Camberwell Community Council

Supplemental Agenda

Item No: 6	Classification Open	Committee: Camberwell Community Council	Date: 21 July 2011
From: Head of Development Management		Title of Report: Addendum Late observations, consultation responses, information and revisions.

ITEM 6.1 - LAND TO THE REAR OF 37 AND 38 GROVE PARK, LONDON SE5 8LG

DRAWING TITLE Grove Lane Elevation: Ex'ng & Proposed	SCALE 1:100 @ A1
JOB NO CGJUR / 09	REVISION OR 1300 (A1)
PROJECT Cambridge Green United Reformed Church Development	DRAWN BY AM
64 Grove Lane, London SE5 8SN

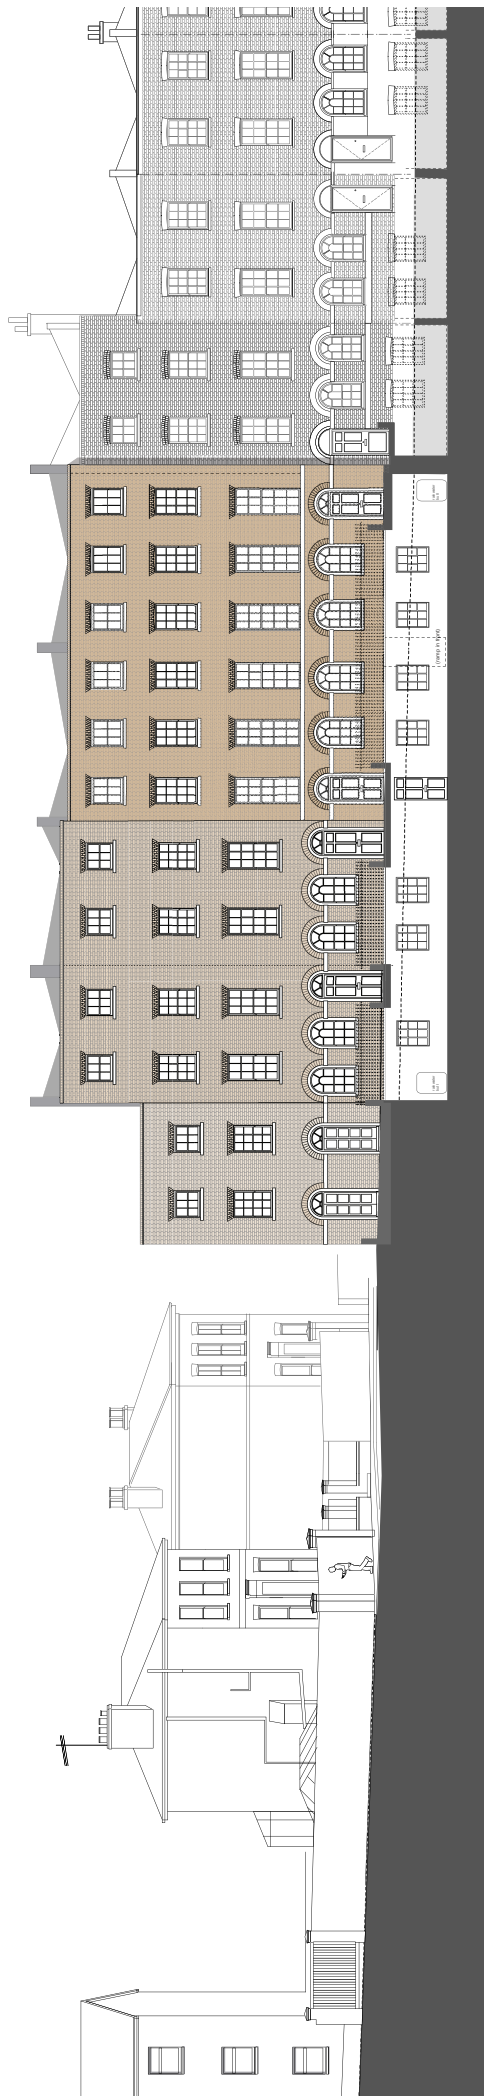
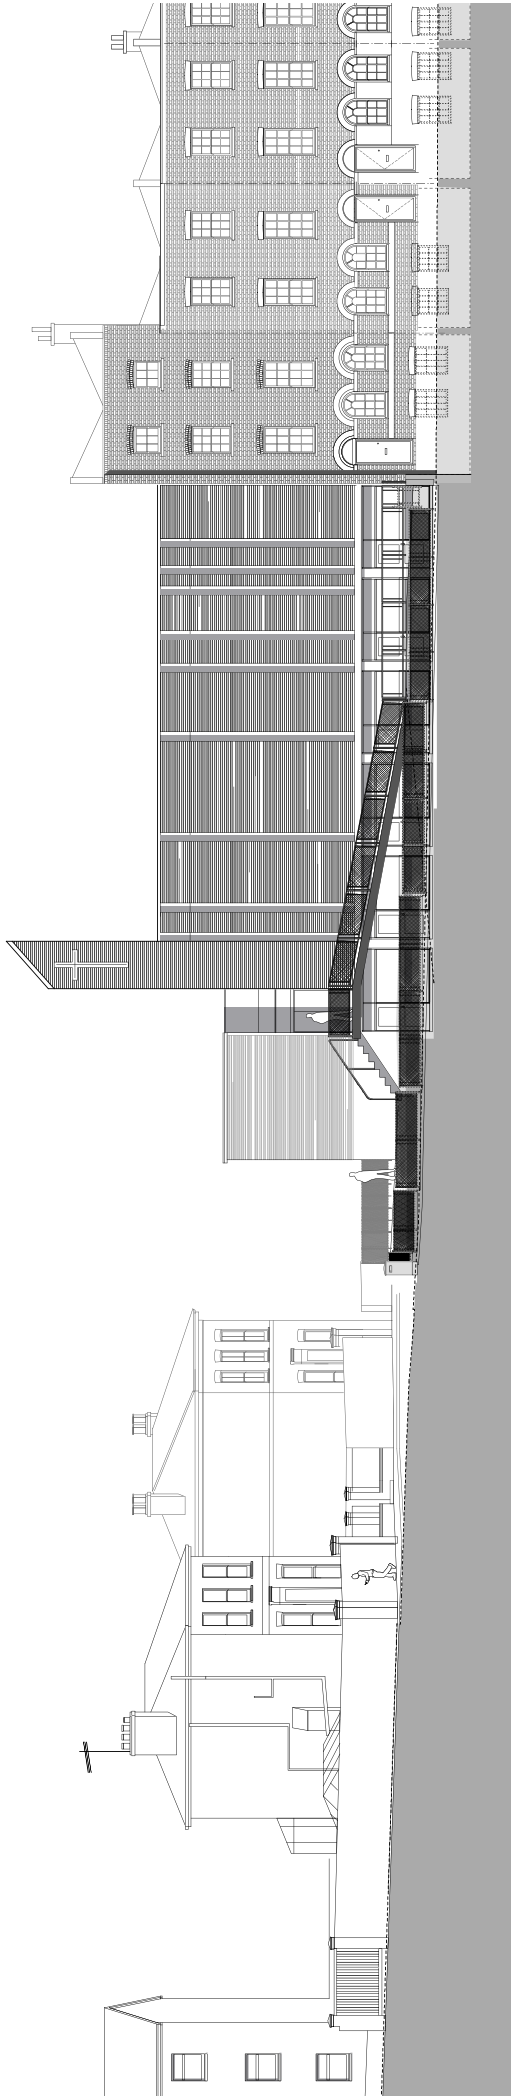
- 36 A revised front elevation has been submitted for this application, which is attached to the addendum. Officers consider the elevation as originally submitted to be preferable, but Members may wish to consider this as an alternative.

REVISION	DESCRIPTION	DATE
E	Amend Society Suggestion	July 11
D	Planning Submission	May 11
C	Revised Planning Application	May 11
B	Revised Planning Application	May 11
A	Planning Note	May 11
